## SUBSURFACE SEPTIC DISPOSAL SYSTEM REPLACEMENT

25 HARDING ROAD NORTH READING, MASSACHUSETTS ASSESSORS MAP 62 PARCEL 28

CHECKED BY: L.J.R. PROJECT No: 21-135 DRAWING: 21135SEP.DWG OF 1

SYSTEM PROFILE

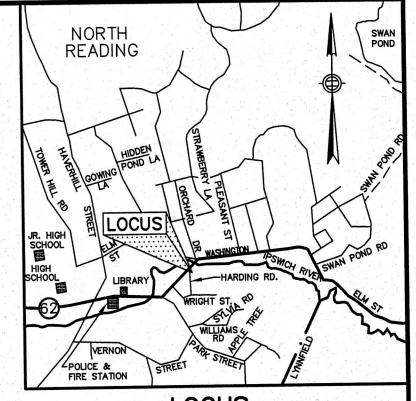
INCREASE SIZE OF

FORCE MAIN TO

3" OR 4" AT MIN.

-FORCE MAIN TO 3" OR 4"

AT MIN. 3FT. FROM D-BOX
